DESIGNED: MBS		ISSUED FOR CONSTRUCTION	
DETAILED: MAK		DATE	
CHECKED: MBS		12/04/15	
APPROVED: PJD		NO. BY CK APP	
DATE: 12/04/15		0 MBS PJD	
PROJECT NO. 182262		REVISED AND RECORD OF ISSUE	
C-20-100		NO. BY CK APP	
SHEET OF		0	
BEDFORD REGIONAL WATER AUTHORITY SMITH MOUNTAIN LAKE WTP & RAW WATER PUMPING STATION / INTAKE		XREF1: INTAKE.dwg	
CIVIL PLAT MAP AND ADJACENT PROPERTY		XREF2: 2D-C-20-INTAKE.dwg	
BLACK & VEATCH Building a world of difference		XREF3: BORDER.dwg	
Black & Veatch Corporation Virginia Beach, VA		XREF4: Delphos Seal.dwg	
VER: 1000		USER: KOF48353

**BEDFORD REGIONAL WATER AUTHORITY**  
**SMITH MOUNTAIN LAKE WTP & RAW WATER PUMPING STATION / INTAKE**  
**CIVIL INTAKE STRUCTURE SITE PLAN**

BEDFORD REGIONAL WATER AUTHORITY SMITH MOUNTAIN LAKE WTP & RAW WATER PUMPING STATION / INTAKE	CIVIL INTAKE STRUCTURE PIPING PLAN
---	--

ECN 3  
Revised

INTAKE STRUCTURE - PIPING PLAN  
1" = 10'-0"

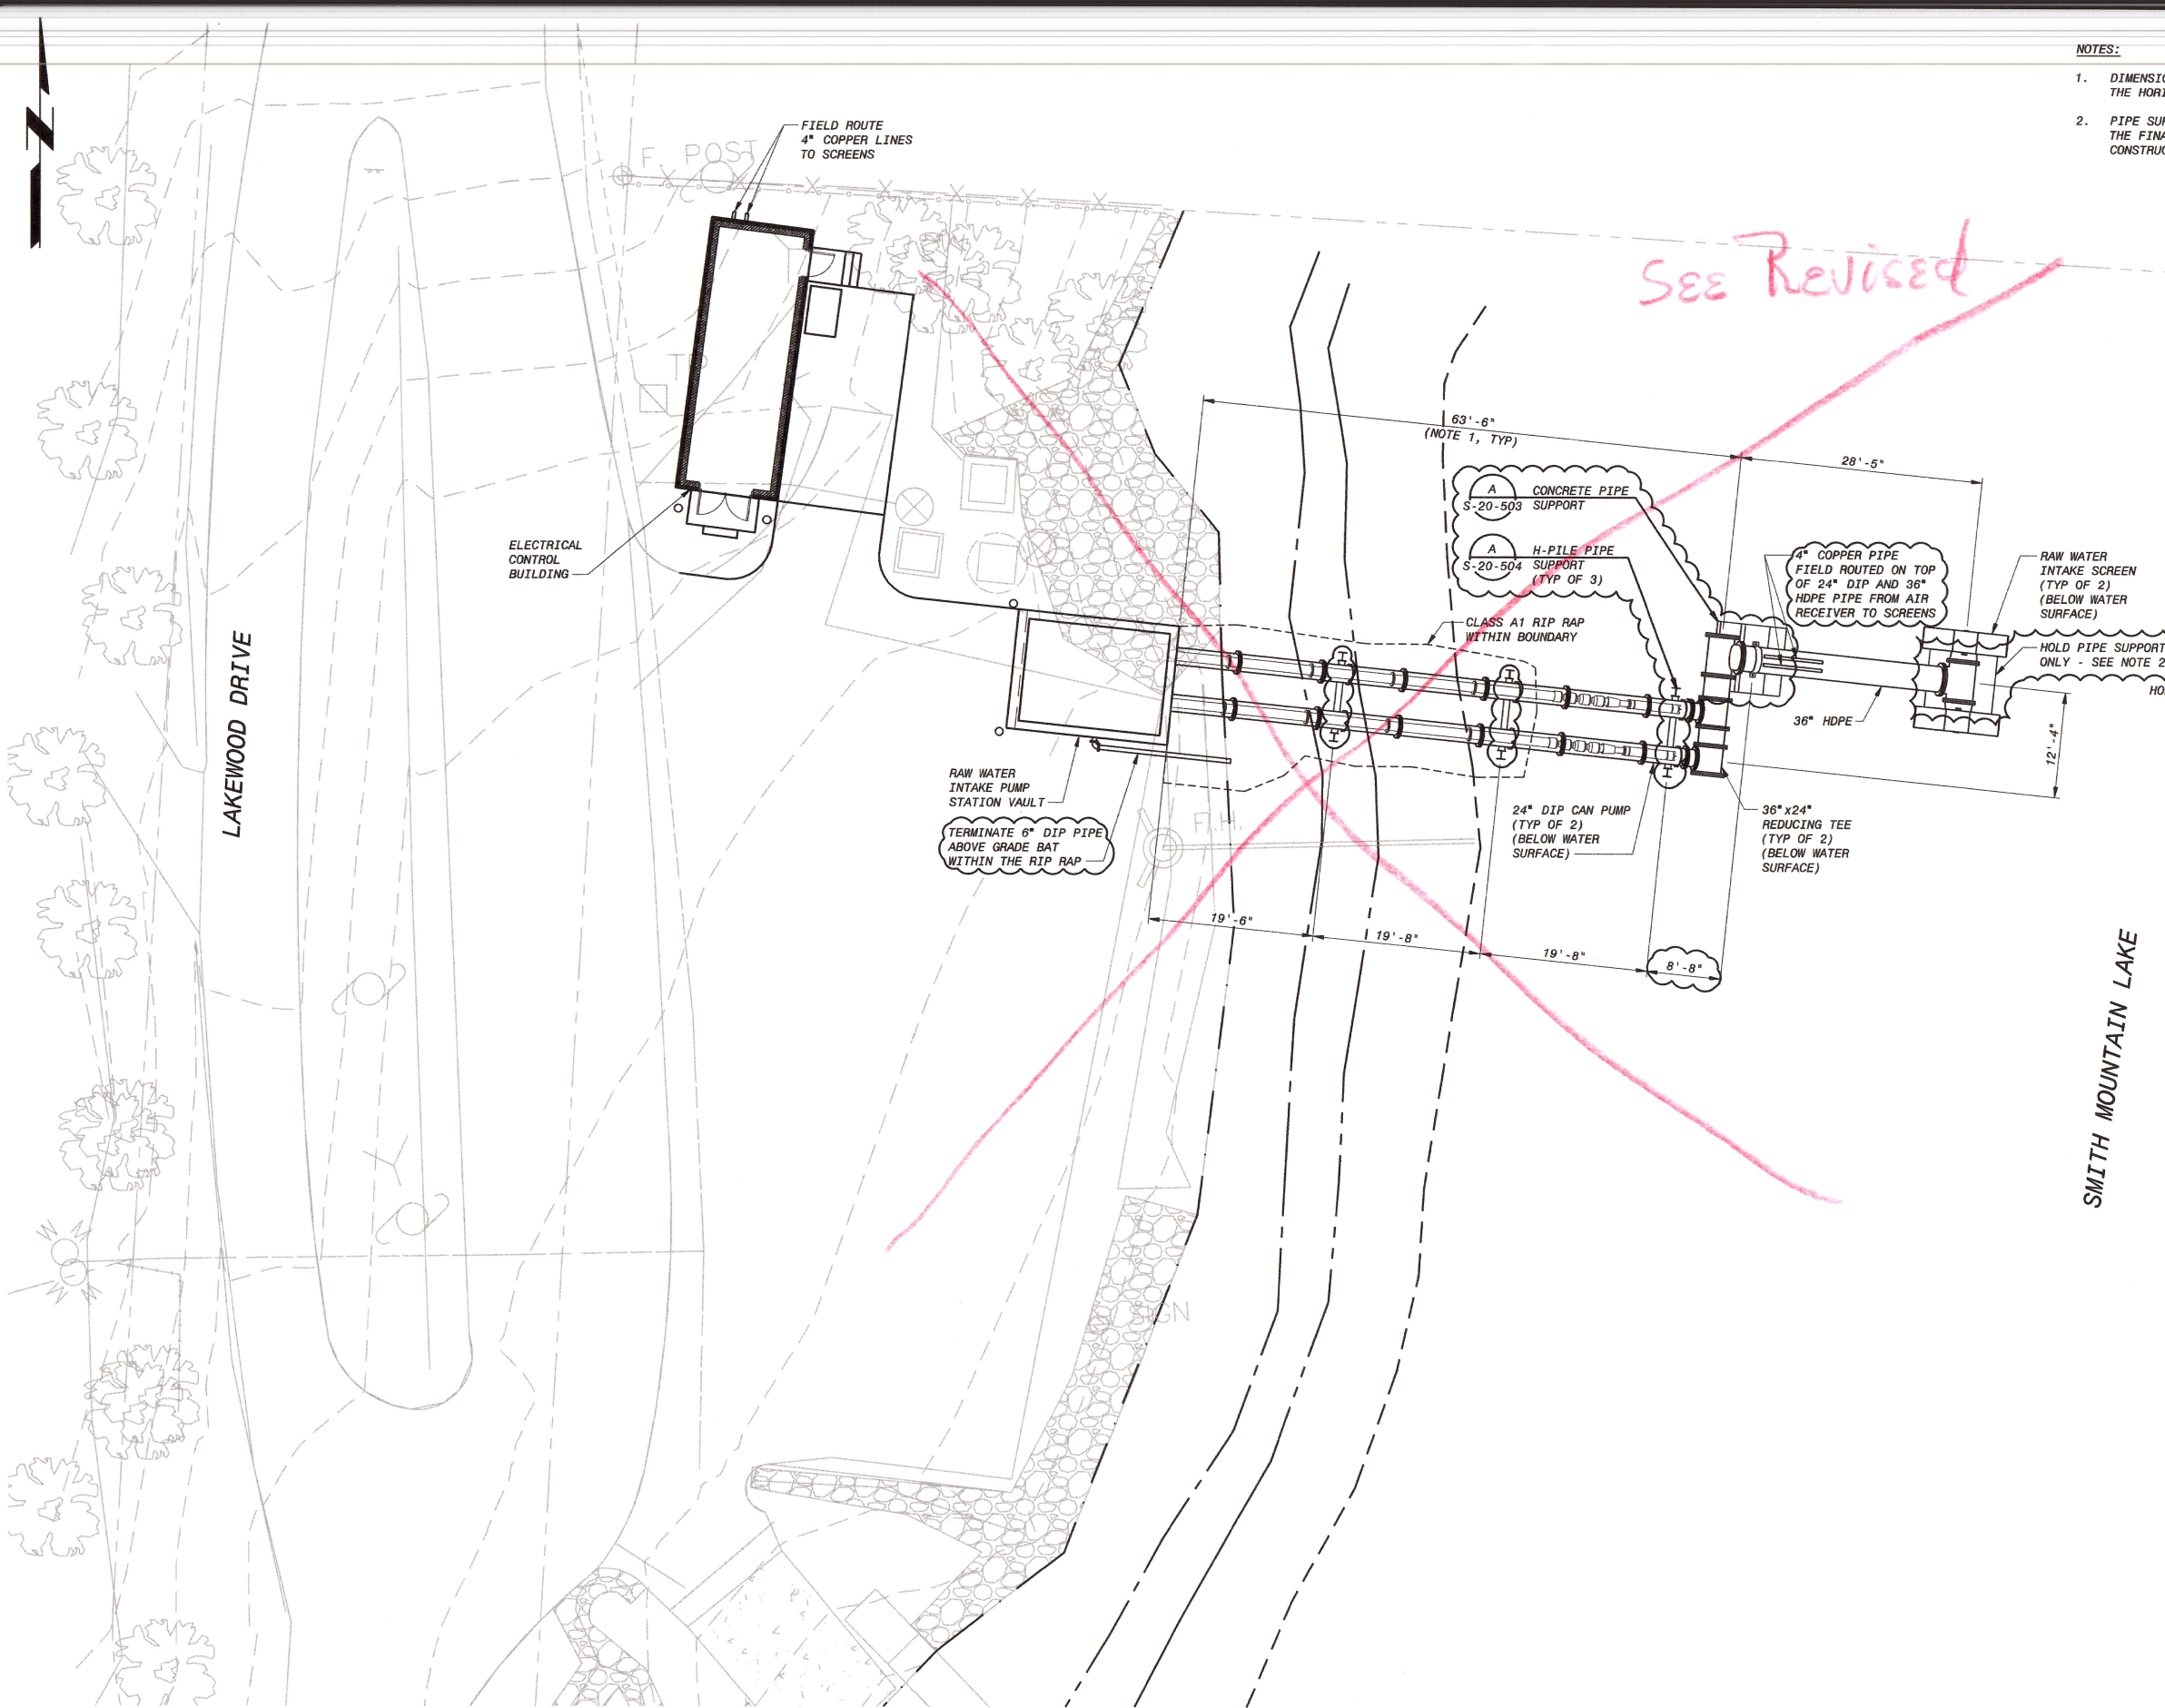
RFI 30

RFI 27

CHANGE ELBOW TO A 18"X18"X18" TEE. CAP THE TEE TO THE SOUTH.

HOLD PIPE SUPPORT ONLY - SEE NOTE 2
